CONSERVATION DEPARTMENT DETAILED AGENDA

SCC Meeting Date:

March 10, 2022

PROPOSED SEPTIC SYSTEM DESIGN
CLEAR WATER ENVIRONMENTAL
SEPTIC SYSTEM DESIGN | LAND PLANNING

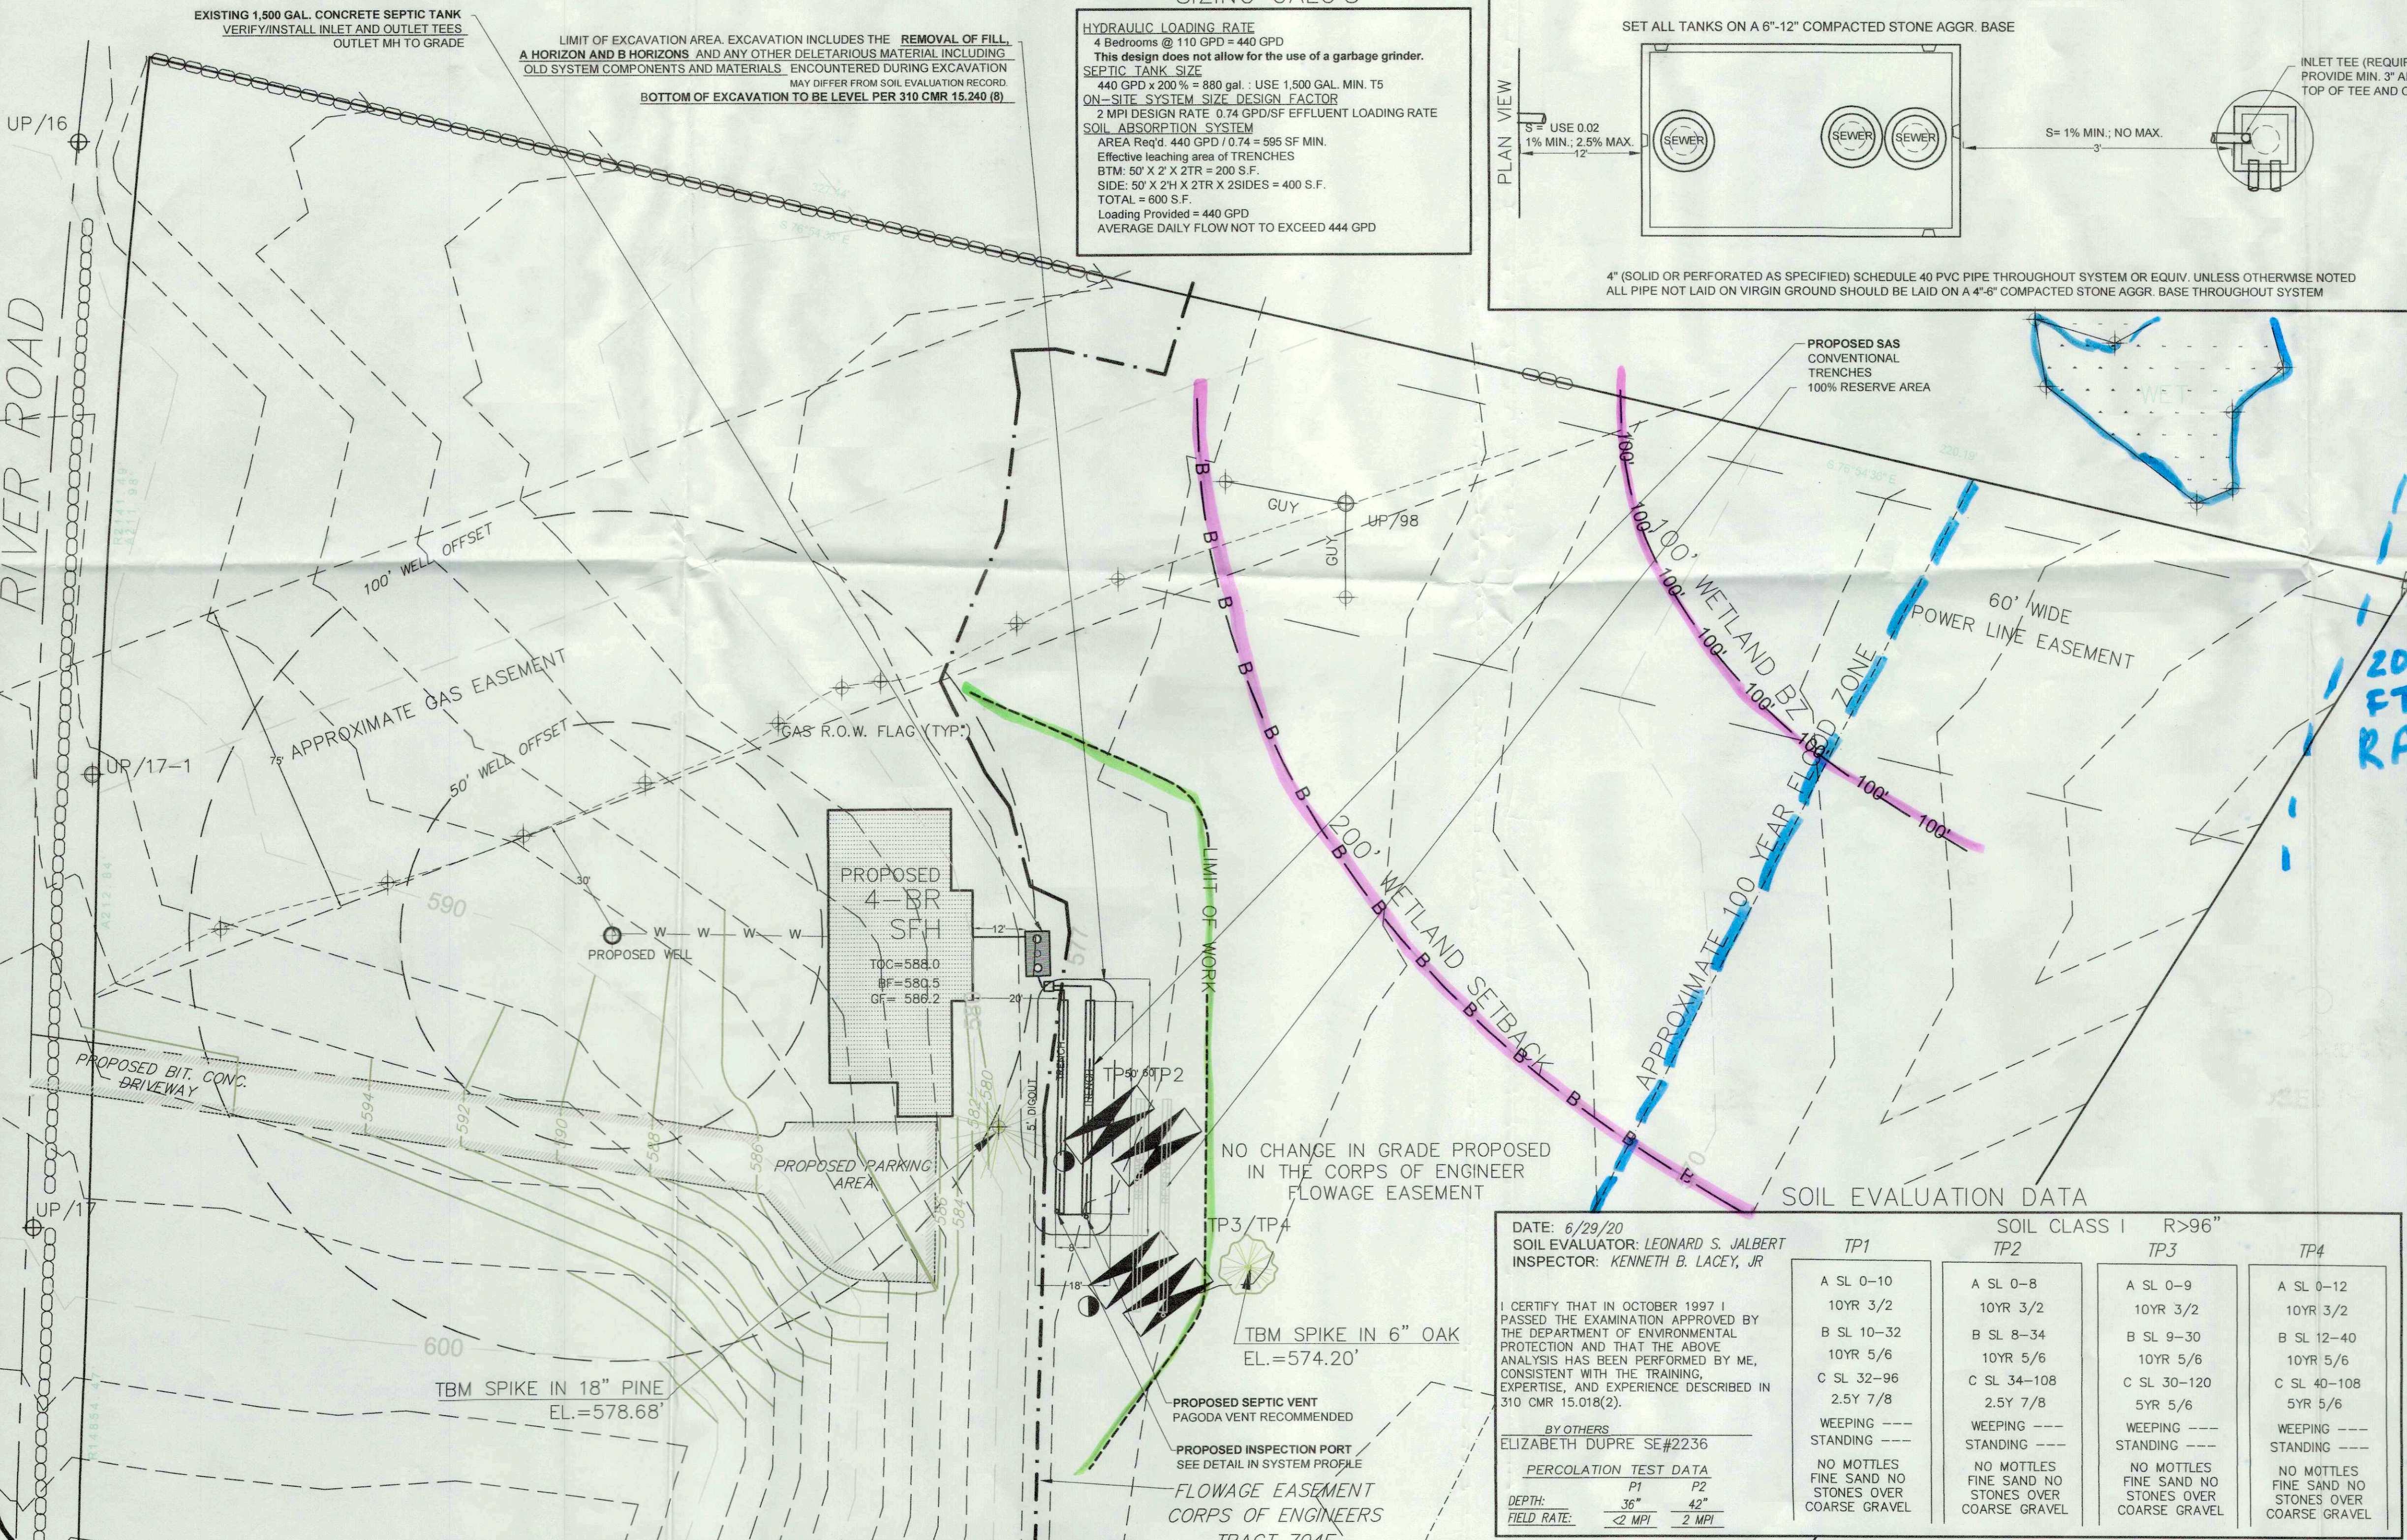
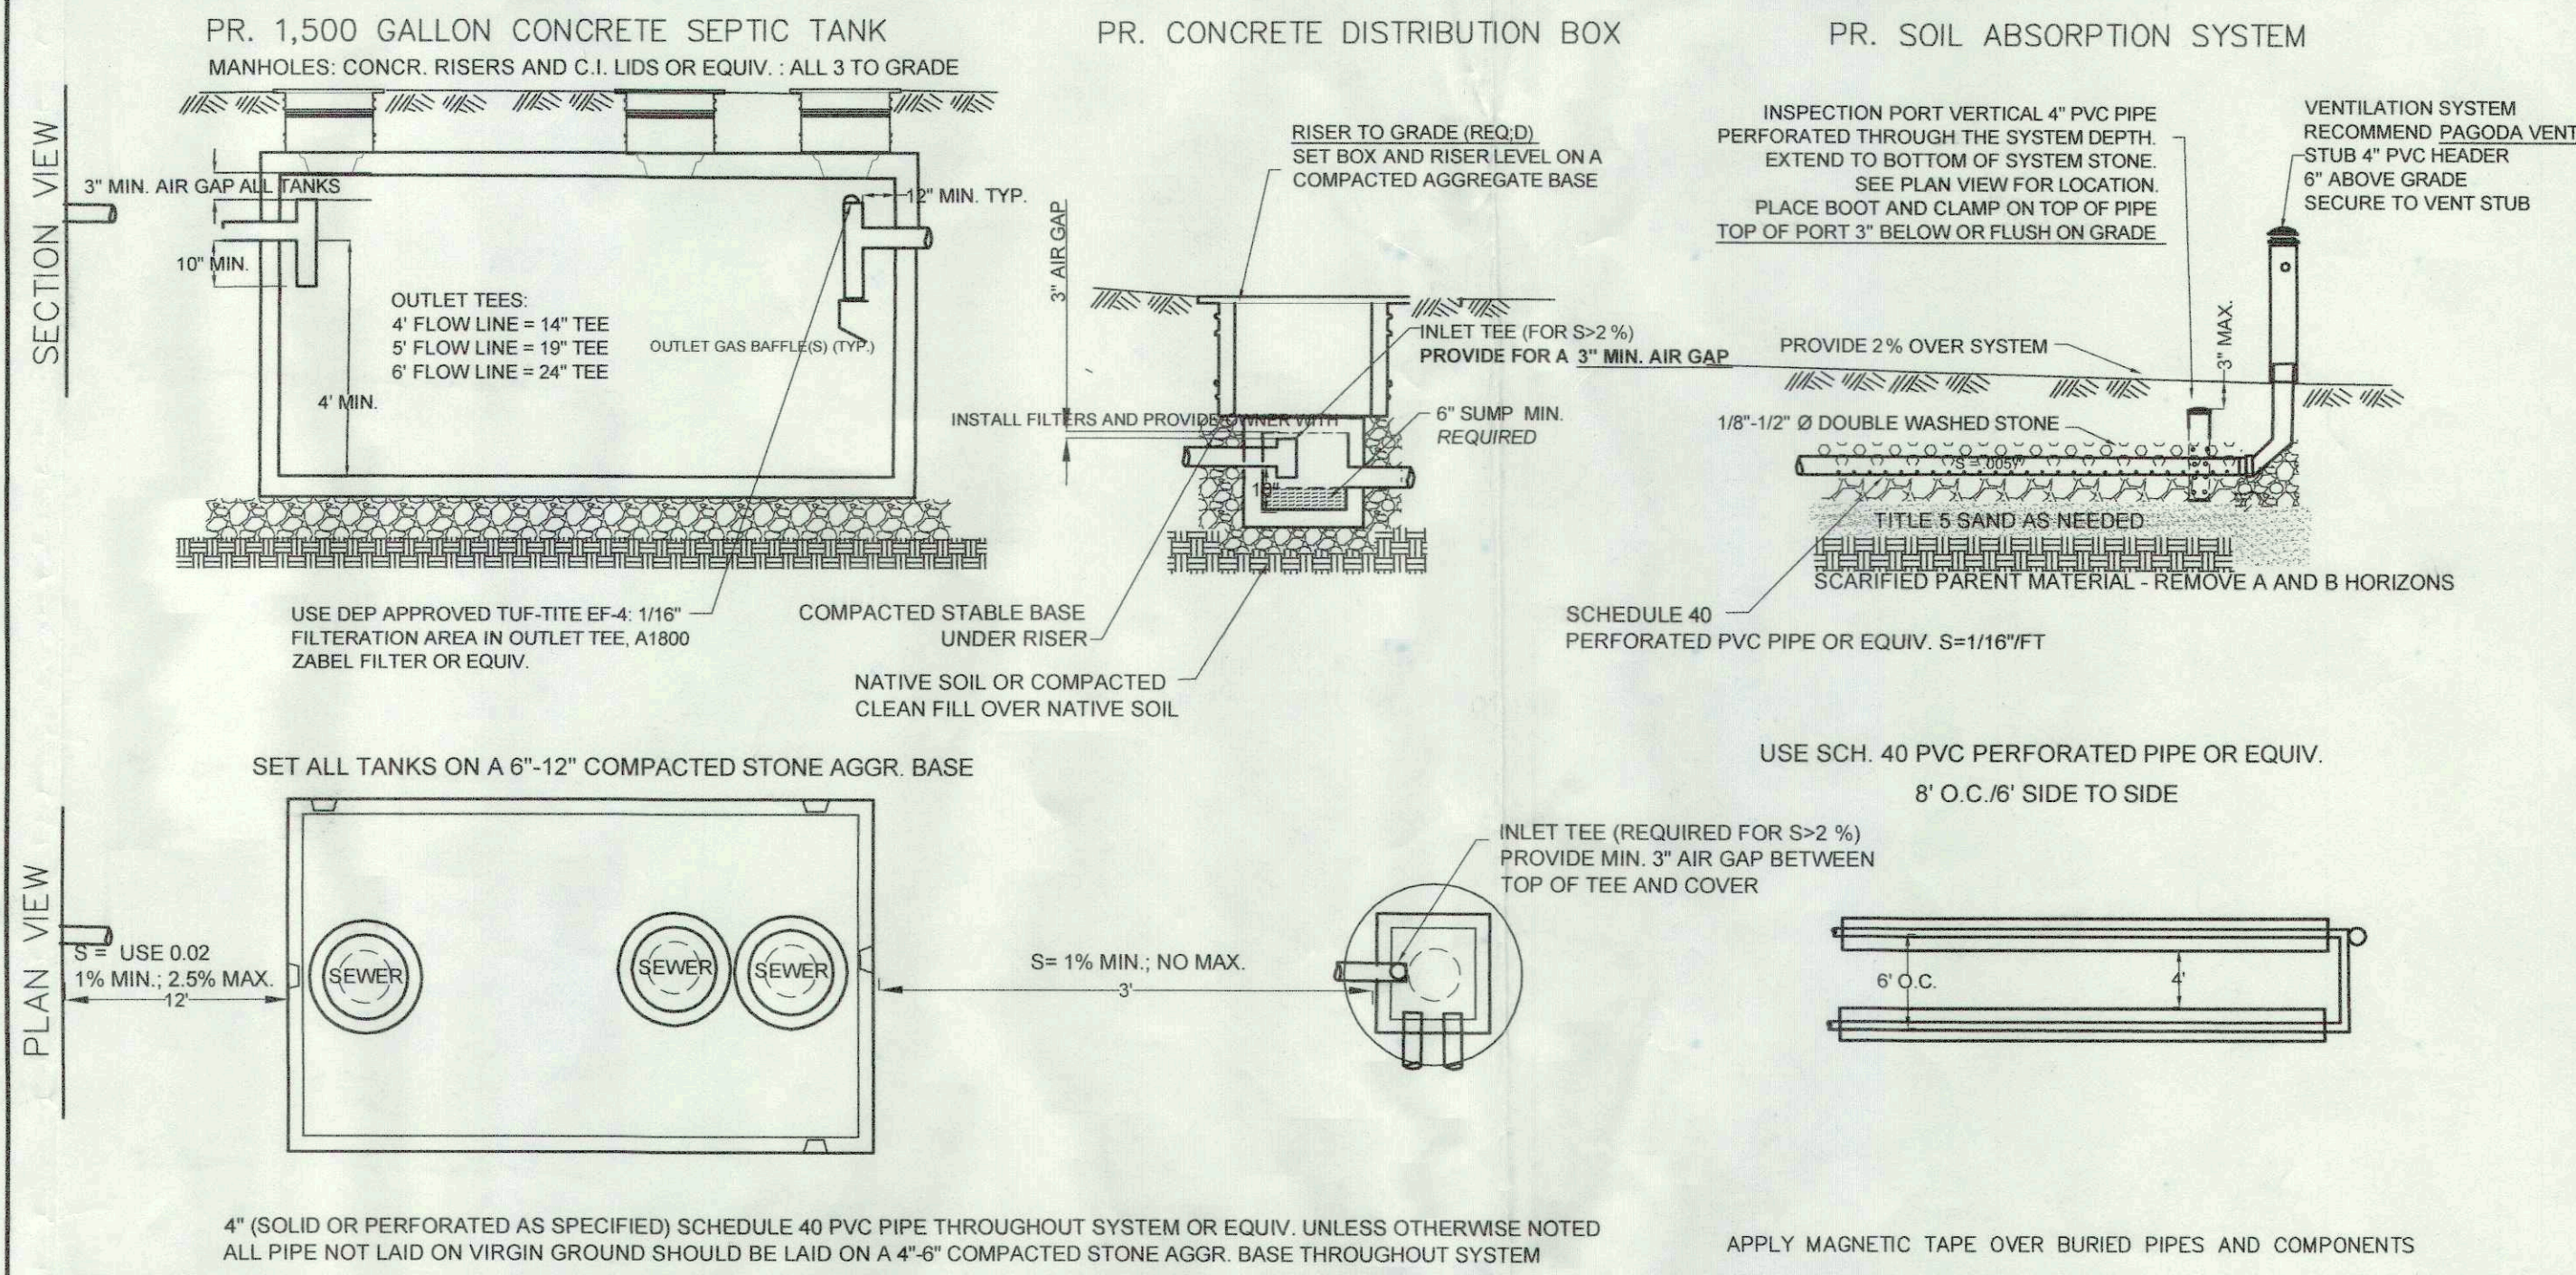
- NHESP is requiring entrenched silt fence to keep species out of the work area during construction along the entirety of the limit of work.
 - Site contains Riverfront Area, Bordering Land Subject to Flooding (BLSF), BVW, and Buffer Zone. Work/development, to include a developed yard, has been cited to be just outside of SCC's 200 ft BZ and resource areas. Originally some work was proposed in BZ but revised to avoid.

- Work shown within ACOE flood easement areas. ACOE has given approval as no fill proposed. ACOE flood easement is not the same as BLSF. ACOE easement more expansive than 100-year floodplain.

- Negative #6, the area and/or work described in the request is not subject to the SWB.
 - Require erosion controls at the limit of work, between the resource areas and work, to avoid potential for inadvertent work in jurisdiction or runoff impacts to resource areas during work.

TITLE:
PLAN OF LAND
263 & 277 NEW BOSTON ROAD
Sturbridge, MA (Worcester County)

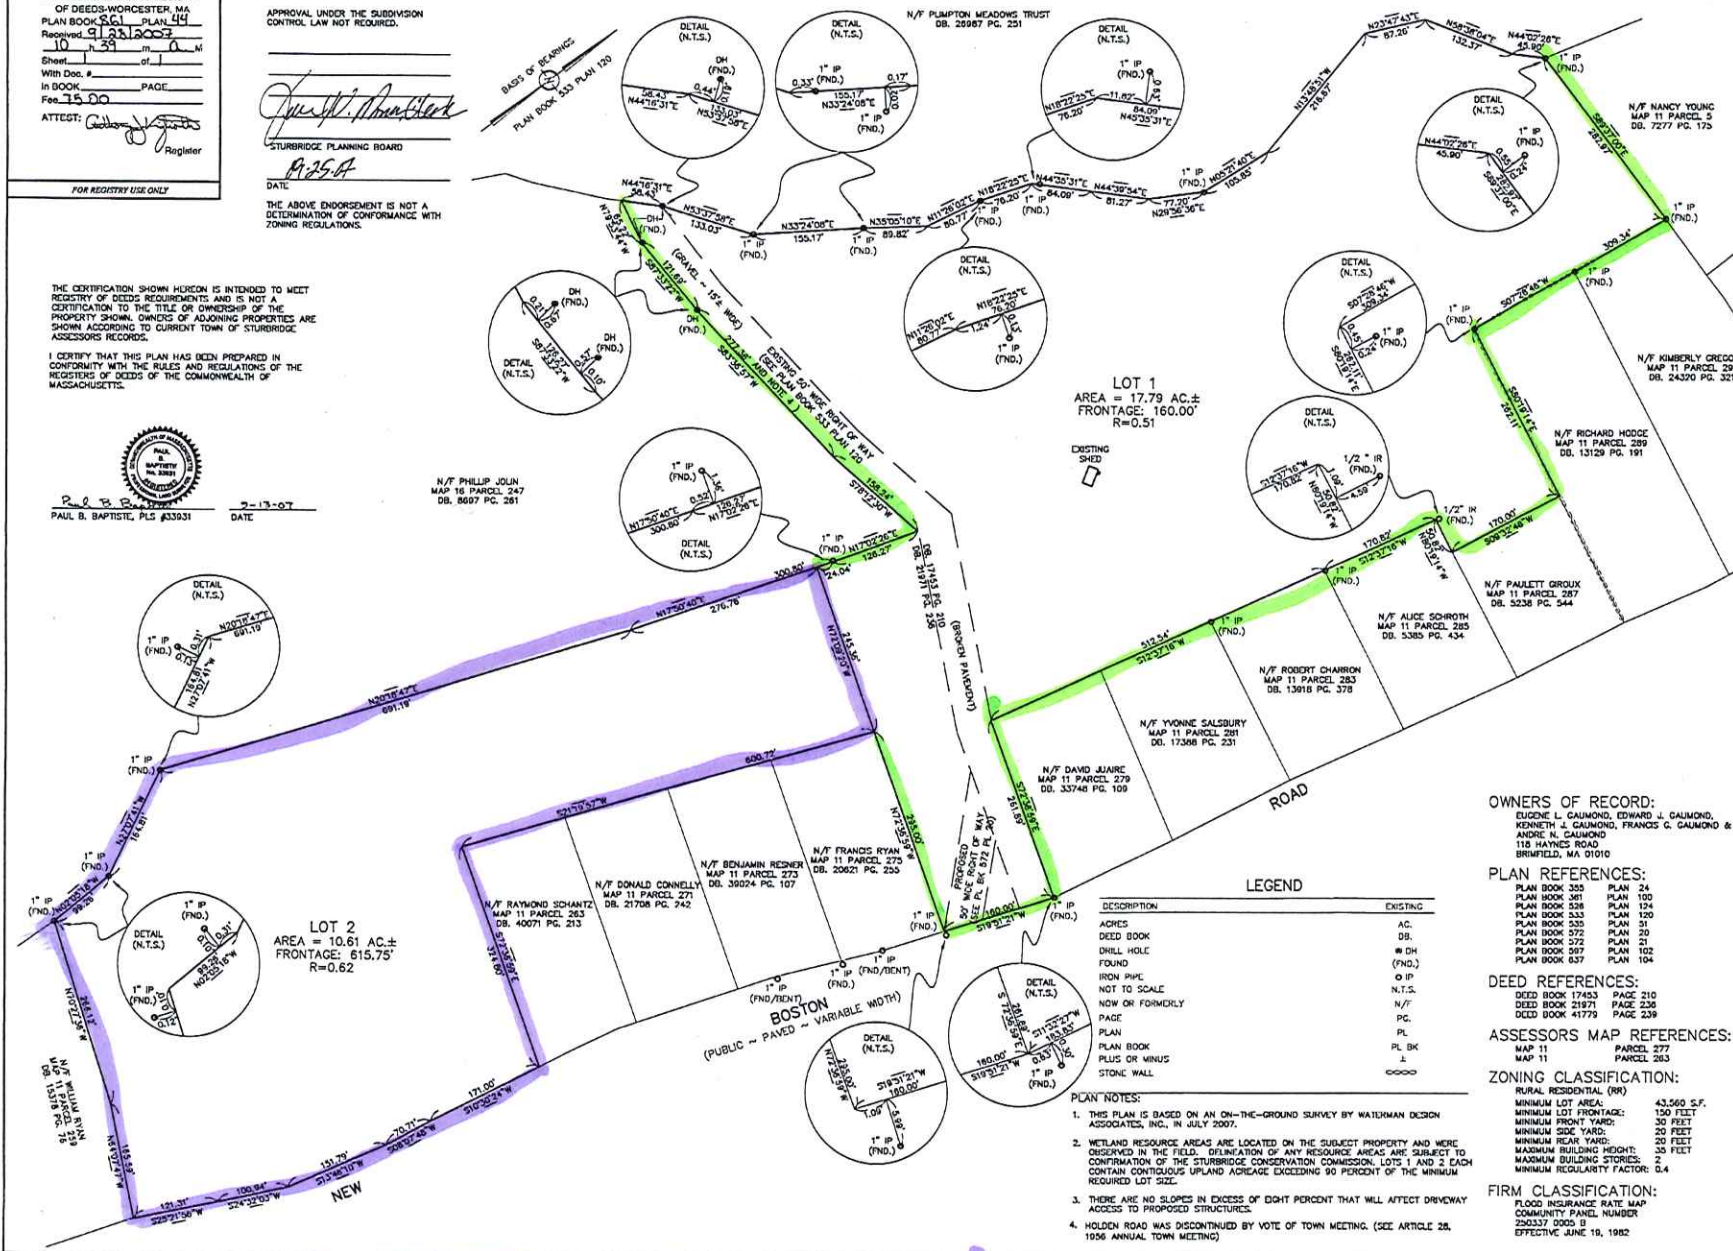
- The PVP is primarily located on an adjacent parcel 269 New Boston Road. The SCC cannot authorize access to this property. Landowner permission would be needed.

- The site appears to have additional challenges beyond the presence of the PVP. The entirety of the road frontage area is very steep and contain wetlands below the area. It would seem challenging to have access to this site with these constraints meeting the SCC’s requirements and the DPWs. It would also seem challenging to access the rear portion of the site (uplands) with a driveway through the site meeting the SCC’s standards.

- It appears that this parcel has been subdivided over time, most recently in 2007, with parcels or a parcel where the rear portions of the site would have had access without impacting wetlands. A self-imposed hardship could have been created by the former owner.

- The site is also mapped as Priority and Estimate Habitat. Early coordination is strongly recommended as they may have concerns.
 - Additional site due diligence should be conducted beyond reviewing the PVP. A wetland delineation should be conducted and some initial site survey to assist with evaluating if this site can even meet permitting standards. A review of sub-division history of the land seems warranted too.
